Access Compliance Report

Public Rights-of-Way

(Curb Ramps)

Intersection ID: 3193	Main Street: HIGHCROFT_LN	Cross Street: STONEYKIRK_LN	Location: SE
ADA ID: 3B70630BD2C9	Ramp Type: Perp	Initial Pass/Fail: Pass	Overall Compliance: No
Severity Score: 17.75			
Codes/Mitigation Info/Possible Solution		Field Measurements/Component Compliance

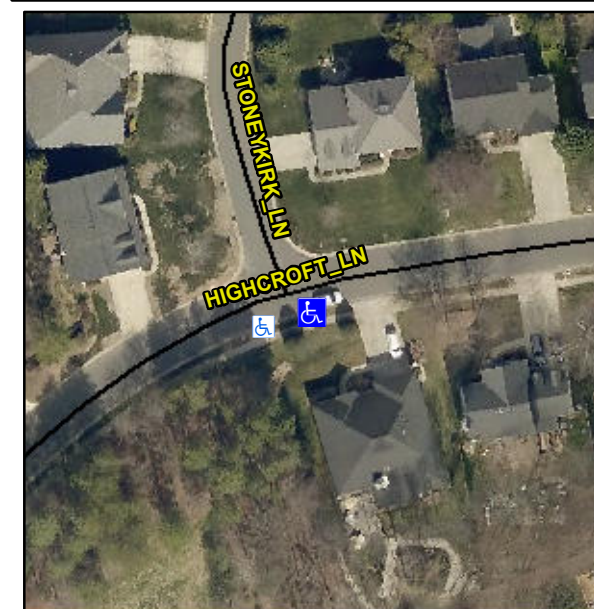
Not Found, R304.5.3, R305, R302.7.2

Compliance	Description	Data	Compliance	Description	Data
N/A	Ramp Length (in)	48.0	Yes	Ramp Slope (%)	6.0
Yes	Ramp Width (in)	48.0	No	Ramp XSlope (%)	3.9
N/A	Flare Type LT	Sloped	N/A	Flare Type RT	N/A
N/A	Flare Slope LT (%)	2.1	N/A	Flare Slope RT (%)	5.4
N/A	Flare Traversable LT?	No	N/A	Flare Traversable RT?	No
Yes	Landing Length (in)	48.0	No	DWS Provided?	No
Yes	Landing Width (in)	48.0	N/A	DWS Contrast?	No
Yes	Landing Slope (%)	1.3	N/A	DWS Length (in)	N/A
Yes	Landing X Slope (%)	1.4	N/A	DWS Full Width?	No
N/A	Landing Curb? (Y/N)	No	N/A	DWS Offset (in)	N/A
N/A	Shared Landing?	No			
Yes	Gutter Ponding?	No	Yes	Gutter Slope (%)	1.1
No	Gutter Lip Ht (in)	0.5	Yes	Gutter X Slope (%)	2.9
N/A	Painted X Walk1?	No	N/A	Painted X Walk2?	N/A
	X Walk 1 Direction	To N		X Walk 2 Direction	N/A
N/A	X Walk 1 Width (in)	N/A	N/A	X Walk 2 Width (in)	N/A
	X Walk 1 Slope (%)	5.0		X Walk 2 Slope (%)	N/A
	X Walk 1 X Slope (%)	3.8		X Walk 2 X Slope (%)	N/A

N/A	Ramp inside XWalk1?	N/A	N/A	Ramp inside XWalk2?	N/A
	Road Slope (%)	N/A	N/A	Clear Space?	Yes
	Road X Slope (%)	N/A	N/A	Clear Space to XWalk (in)	N/A
Yes	Any Obstructions?	No	Yes	Storm Grate/Utility Hazard?	No
	Obstruction Type			Storm Grate/Utility Type	
		N/A			N/A
			Yes	Surface Condition? (G/P)	Good

Remove & Replace Entire Ramp.
